Facilities & Operations Committee Meeting August 2026

RE: North Penn High School BP-2
Change Order Request #19 Utility Conflicts
Mar. 12 thru Apr. 06

Re: High School Additions and Renovations Phase 2

Subject: Change Proposal – ASI #6 Rework Switches at Ramp H Pod

1 FIRST FLOOR PLAN - POWER - AREA B
BP2-E301.B SCALE: 1/8" = 1'-0"

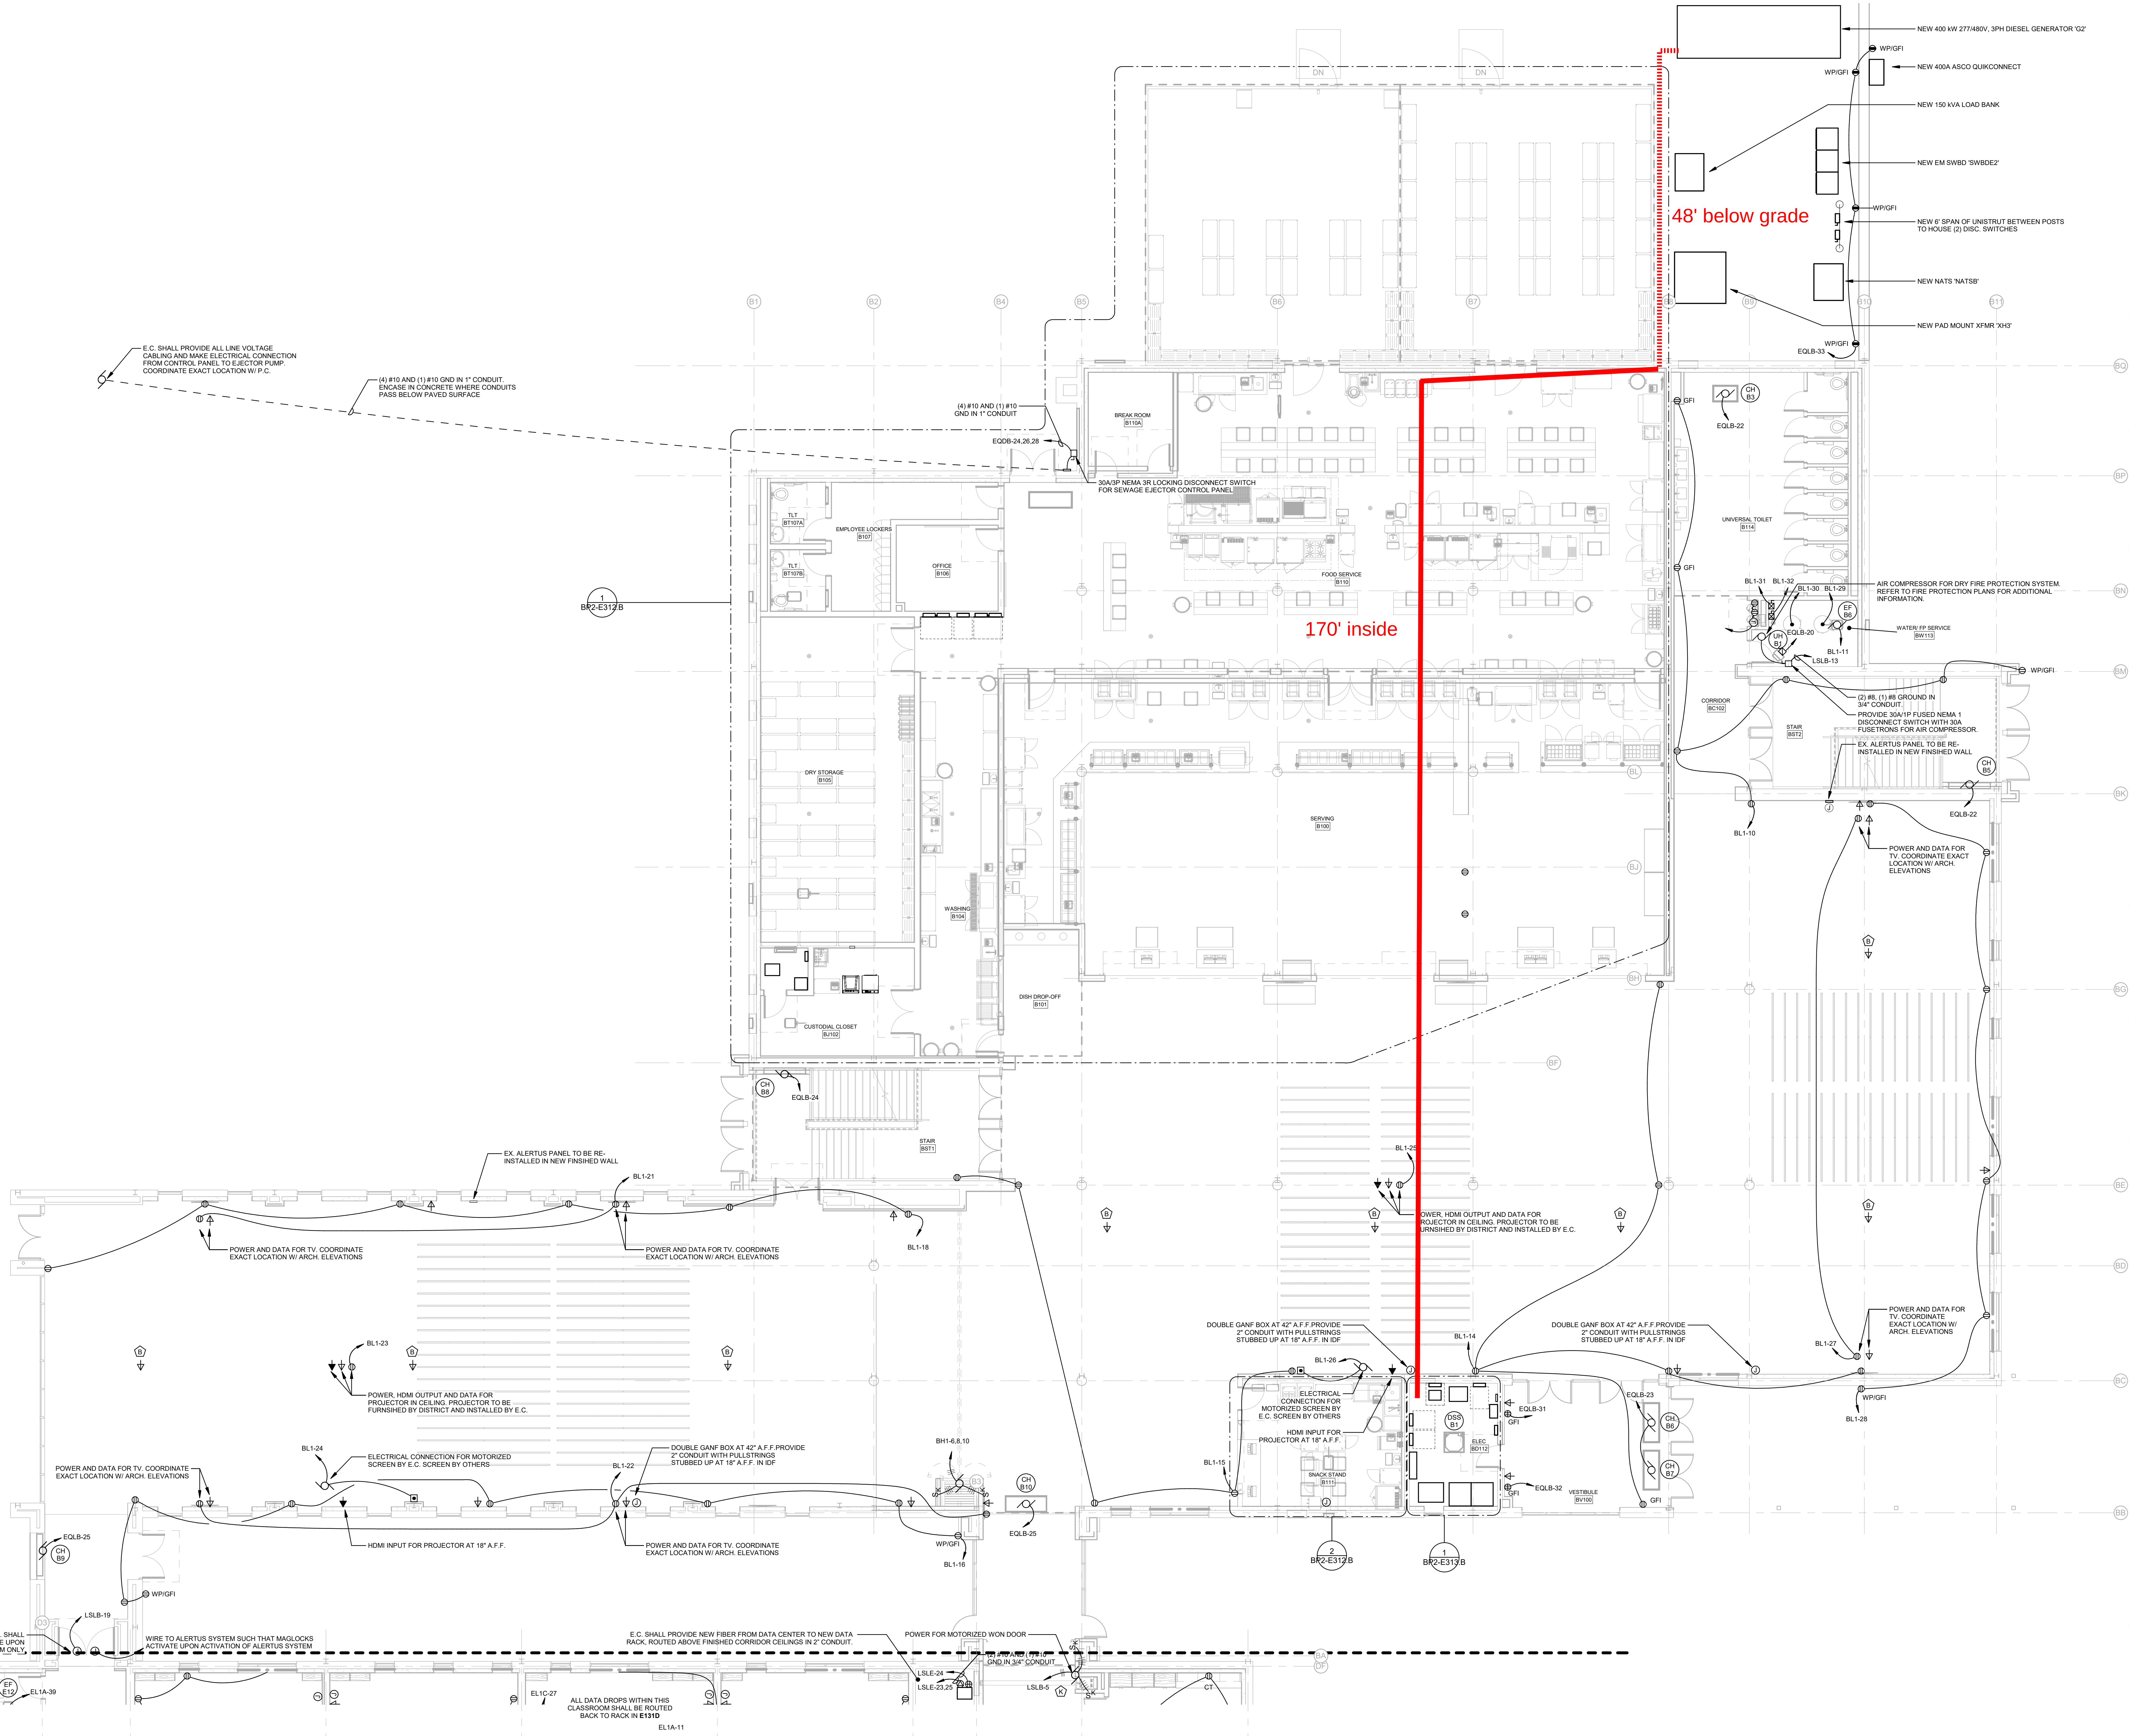
Drawing E502 indicates a 100a load center to be integral to the 600 kw generator labeled 'G1'. The 500kw generator labeled 'G2' does not have a note indicating an integral load center. Spec page 263213-15 section 6 sub section 5 for generators calls out a load center to be integral to the generators. Is generator G2 to be supplied with an integral lead center? If so please provide panel designation, wire size, and conduit size.

1. RFI Number 003	Responsible Contractor Wescott Electric	Date 09/30/2025
Description: Drawing E502 indicates a 100a load center to be integral to the 600 kw generator labeled 'G1'. The 500kw generator labeled 'G2' does not have a note indicating an integral load center. Spec page 263213-15 section 6 sub section 5 for generators calls out a load center to be integral to the generators. Is generator G2 to be supplied with an integral lead center? If so please provide panel designation, wire size, and conduit size.		
References: 263213		
Requested By: Darrell Putnam		Date 09-29-25

Generator 'G2' shall be provided with a 100A 120/208V integral load center, per specification to feed all generator accessories as indicated in note at generator 'G1' on sheet BP2-E502. Load center shall be fed out of new 100A/3P breaker in provisional spaces 'EQLB-36,38,40' and wired with (4) 3/0 and (1) #4 gnd in 2-1/2" conduit.

2. A/E Response, or Comments (if applicable): Generator 'G2' shall be provided with a 100A 120/208V integral load center, per specification to feed all generator accessories as indicated in note at generator 'G1' on sheet BP2-E502. Load center shall be fed out of new 100A/3P breaker in provisional spaces 'EQLB-36,38,40' and wired with (4) 3/0 and (1) #4 gnd in 2-1/2" conduit.		
A/E (Signature):	Date	Contract Document Impact ☐ Yes ☐ No Revisions Attached [☐ Yes ☐ No]
